PROFESSIONAL ENGINEERING CONSULTANTS
INCORPORATED

Project: Review of Constructed Retaining Wall
827 Agate St.
St. Paul, MN
PEC #6186

8" BLOCK WALL OPTION

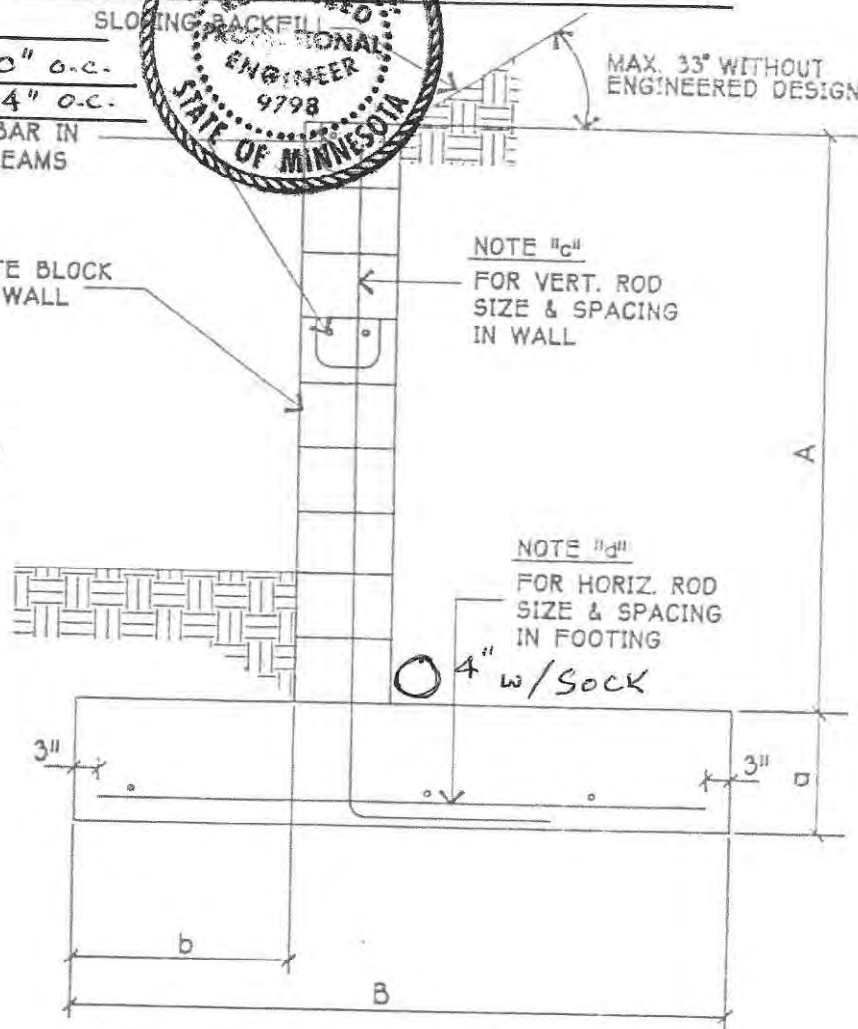
This report concerns our review of a constructed retaining wall behind the front sidewalk at 827 Agate St., St. Paul, MN. The property owner, Alexander Delendik, of Homestead Road LLC, performed his own construction of the wall in general conformance with a detail sheet entitled "8" Block Wall Option." However, the inspection department at the City of St. Paul required that the wall be inspected by a Registered Engineer who could answer to the construction requirements outlined in its identification sheet.

Over the last several weeks, the old retaining wall was demolished and the footing construction removed from the front stairway eastward to the east property line. This amounted to a retaining wall length of slightly less than 30', since a higher concrete retaining wall had been left in place to the west of the stairway. A new footing was dug in behind the sidewalk, providing a new footing which was approximately 12" deep and at least 32" from the existing front sidewalk toward the rear of the property. Reinforced concrete used ½" rebar for the longitudinal steel in three locations at the front of the footing, the rear of the footing, and half-way between these bars. The front and rear bars used a 3" cover of concrete to the dirt forms. The first course of 8" block was placed

in the wet concrete and the footing was stabbed with ½" bars spaced 20" on center toward the rear face of the concrete block first course.

Using this layout of block and rebar, successive courses of 8" concrete block, both double corner and common, were placed with a mason's mortar using a common bond pattern to top of wall height. The completed wall was approximately 4-1/2 courses in height. The vertical rebar were left at least 2 to 3" below top of wall. The completed wall section was then filled with a 4000 psi curb and gutter mix. The rear of the wall received a 4" corrugated drain tile with an exterior sock. The backfill material behind the wall was filled with a granular backfill material and then capped off with the natural excavated soils which consisted of a silty sand material with topsoil mix. The entire backfill region behind the wall was estimated as less than a 33% grade, and the entire backfill area received a grass mix and was covered by a straw mulch.

Since the entire project was completed just recently, the owner will also reseed in the springtime and will seed as needed for a grassy embankment. Based on our observations, the owner has protected the finished grade as much as possible and will continue with seeding and mulching this spring to establish a lawn. We informed the owner that such embankments should drain over the top of the wall and not behind the wall for maximum stability of the wall construction. It is our opinion the owner has used good workmanship on this construction.
